Advisory Committee on Nuclear Waste and Materials (ACNW&M) Questions on Corrosion of the Waste Package and Spent Nuclear Fuel Dissolution

**In Response to Staff Presentations to ACNW&M in 182nd Meeting,
September 18 – 20, 2007**

**186th Meeting of the ACNW&M, February 12 – 14, 2008
U.S. Nuclear Regulatory Commission, Rockville, MD**

Spent Nuclear Fuel Dissolution Rate As a Function of Burnup Under Different Temperatures (T) and Molar Total Carbonate Concentrations (CO₃).

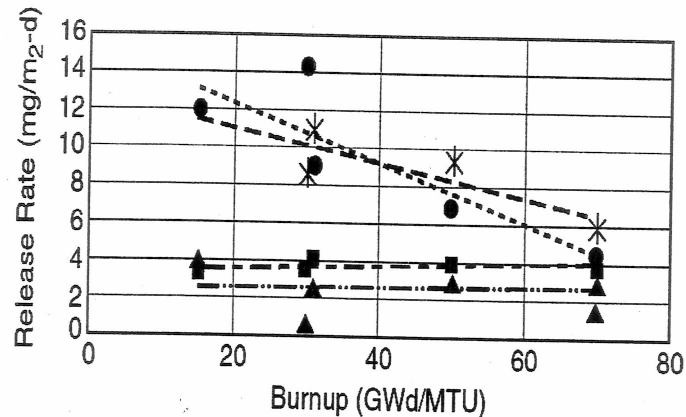
Q 10: Dissolution Rates for High Burnup Fuel

- Available information indicates that high burnup SNF does not increase the dissolution rate.

- Available information indicates that:

- prior dry oxidation of high burnup SNF may increase surface area, to increase dissolution rates (Ahn, 1996).

- hydride formation (Pan, et al, 2007; Ahn, et al., 2007) does not affect dissolution rate, except potentially altering surface area.
